Subject: Almond 2 Power Plant (09-AFC-02)
Data Response Set 1B, Responses to CEC Staff Data Request 19 and
Workshop Queries 1 through 6

Data Responses, Set 1B
Responses to Data Request 19 and Workshop Queries 1 through 6

Almond 2 Power Plant

(09-AFC-02)

FIGURE DR19-1
MODESTO FORMATION
ALMOND 2 POWER PLANT
CERES, CALIFORNIA

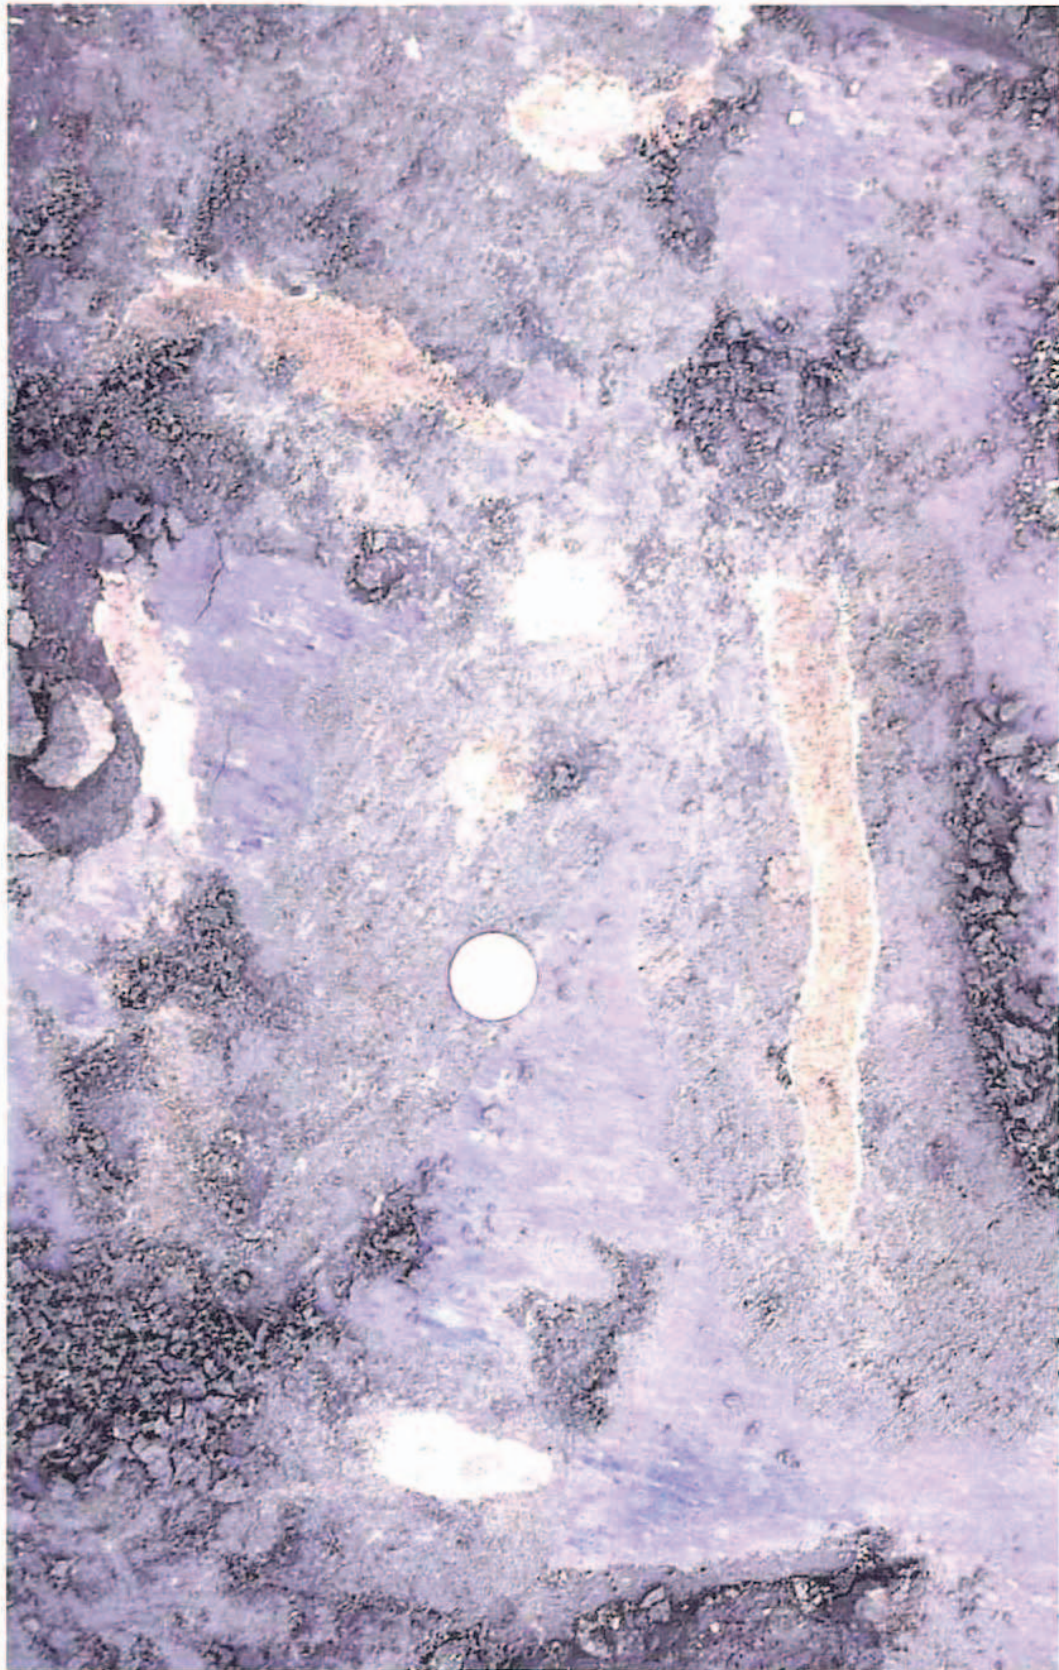
19. Please have the author of the Paleontological section of the AFC provide an assessment, along with the evidence on which the assessment is based, on whether the sediments below 6.5 feet (from the ground surface) at the project site and below 4.0 feet (from the ground surface) along the linear facility routes and at the end of the natural gas line routes are of a geologic age young enough to contain archaeological deposits.

Burow et al. (2004) largely follow the lead of Marchand and Allwardt (1981) and describe three stratigraphic units in the study area relevant to this analysis. The topmost and therefore youngest is the Modesto Formation. The thickness of the Modesto Formation is usually not directly addressed, but it is mapped as largely surficial deposits by Atwater and others (1986). The WEC excavations revealed that it normally ranged from about 6 to 7 feet up to 10 feet deep due principally to paleotopographic variability at the base of the Modesto Formation. The upper 4 feet of the Modesto Formation was inevitably disturbed by agriculture, and consists of a homogenous dark grey-brown sandy silt with a high organic content. Rodent bioturbation (appearing chiefly attributable to the pocket gopher *Thomomys*) was abundantly evident and continued into the lower portion of the Modesto Formation (Figure DR19-1). The lower portion of the Modesto Formation, at depths generally exceeding 5 feet, exhibits a notably higher pedogenic clay content as well as distinct reddening (Figure DR19-1).

FIGURE WSQ-1
SCHOOL BUS LOCATIONS
 ALMOND 2 POWER PLANT
 CERES, CALIFORNIA

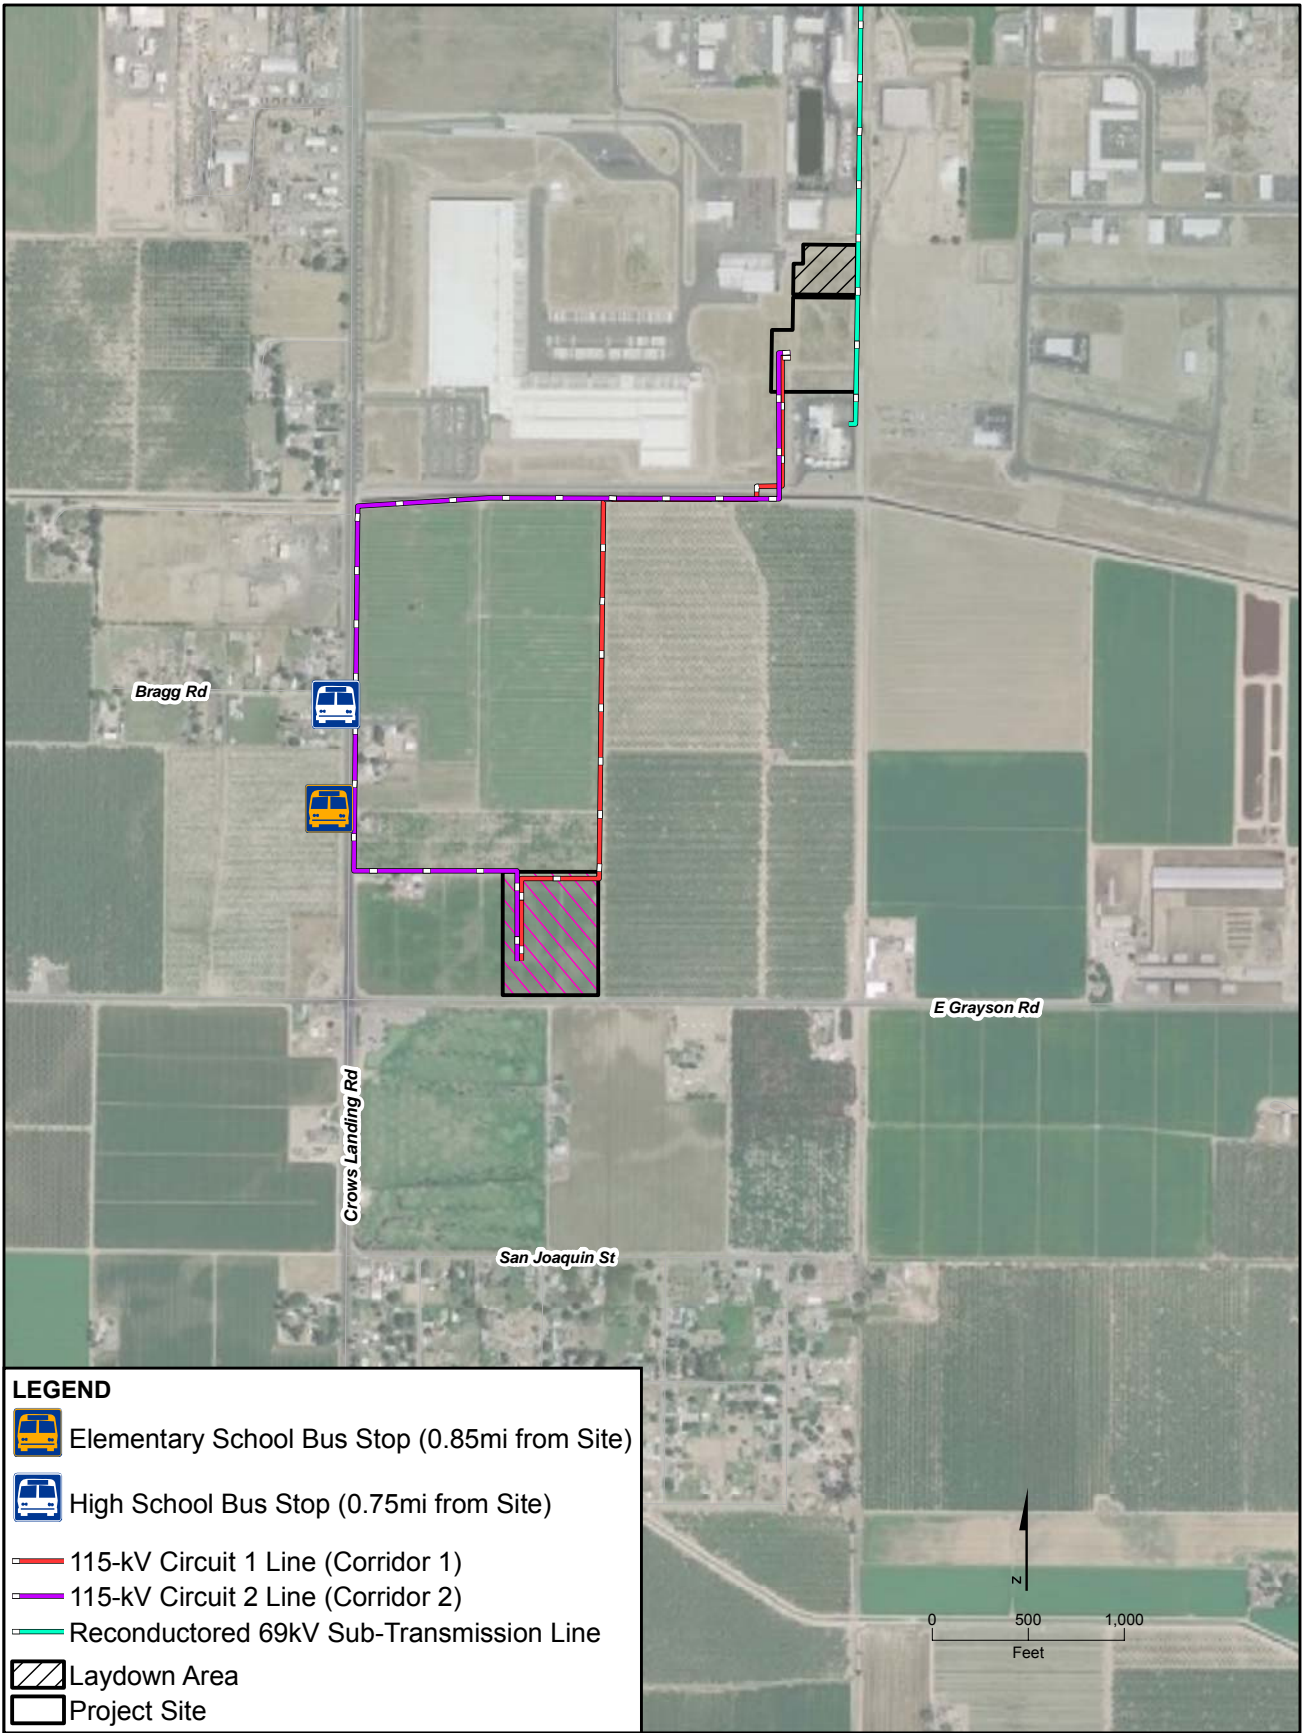
WSQ-1 Please formally docket the figure showing the nearest school bus stop to A2PP.

Response: Please see Figure WSQ1-1.

FIGURE 5
A2PP SIMULATED
GROUNDWATER CONDITIONS
 ALMOND 2 POWER PLANT
 CERES, CALIFORNIA

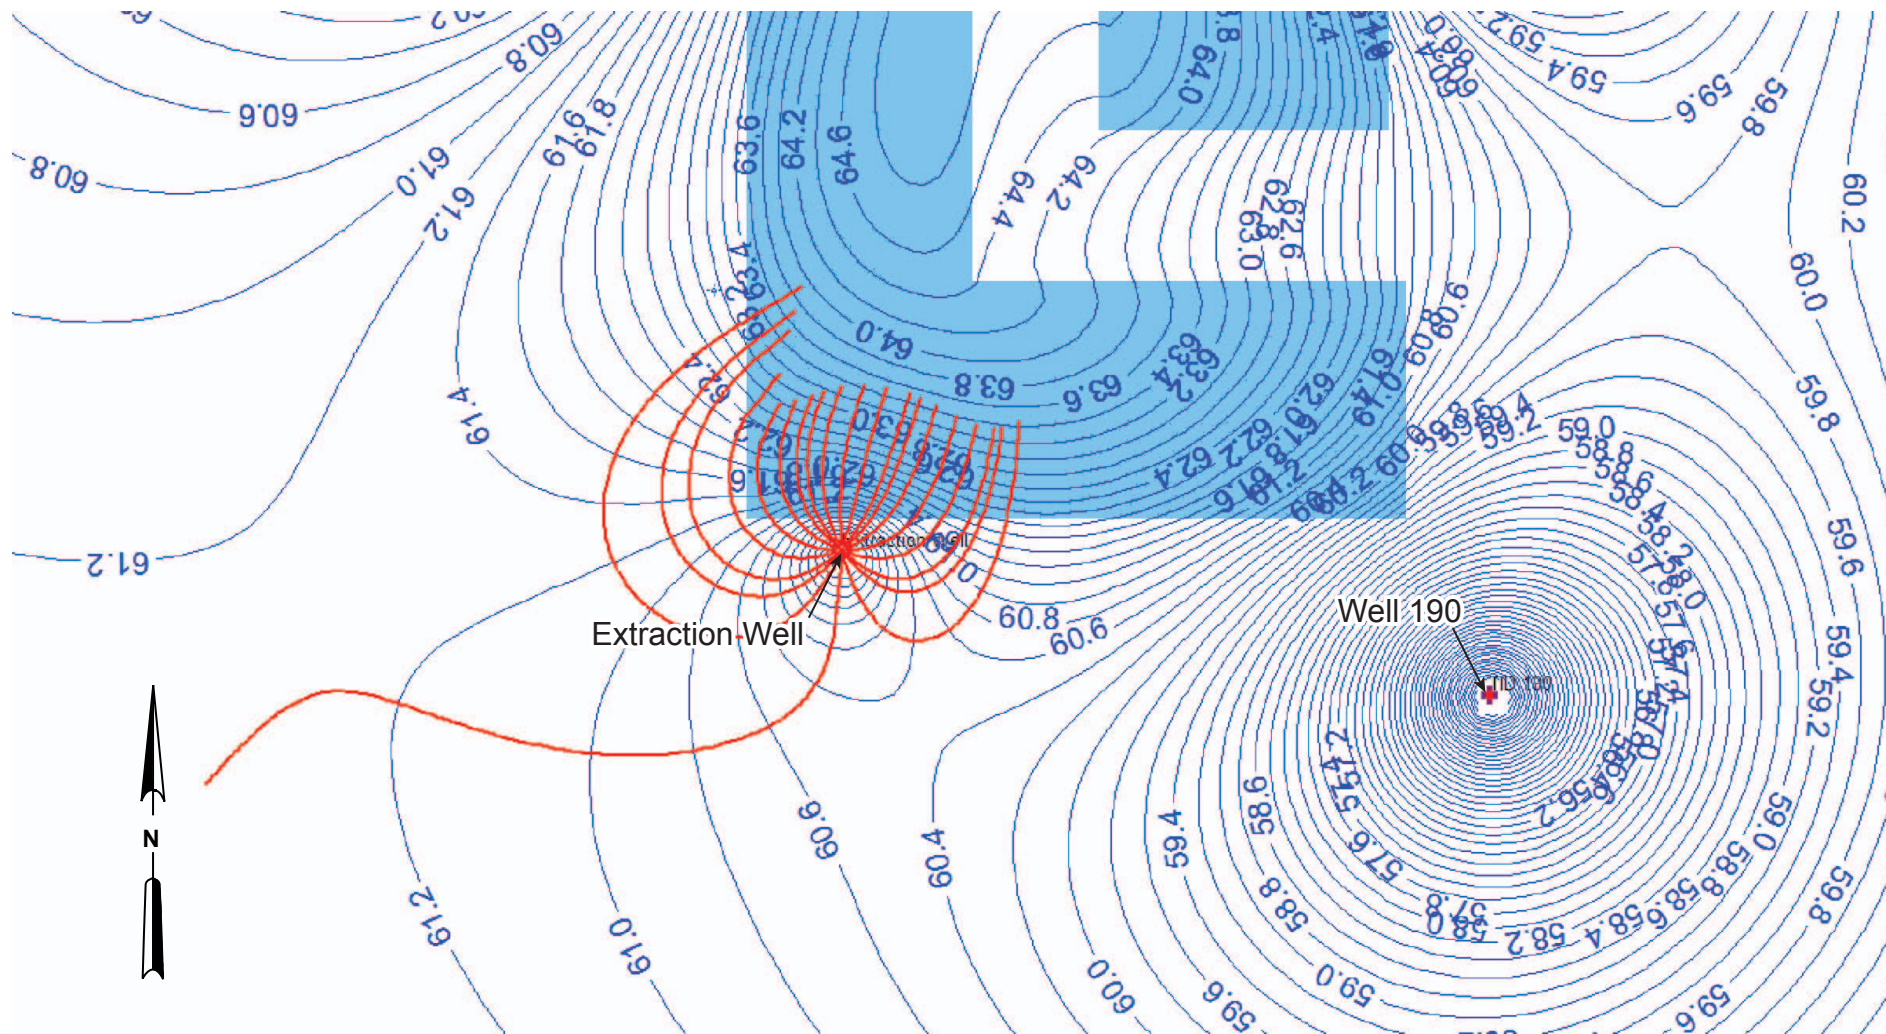
WSQ-4 Staff requested an estimated quantification of how much fresh water was being drawn up by the extraction well on site. Staff was also concerned with the water balance and possible hydraulic issues relating to whether the capacity of the percolation ponds is adequate to support A2PP. Please provide a groundwater model to provide more information on how the extraction well draw-down of fresh sources may affect adjacent users' water.

The model was run to assess groundwater conditions under the proposed pumping operations; results are shown in Figure 5. The results of this simulation compare favorably to

As shown on Figure 5, groundwater pumping at each of the modeled wells has wide-reaching effects on the overall groundwater flow field. However, as indicated earlier, other pumping wells outside of the immediate vicinity of the WWTP were not input into the model and so actual groundwater flow patterns away from the WWTP will be different from those simulated in this project-specific model. The basin-wide model more accurately represents larger-scale groundwater conditions.
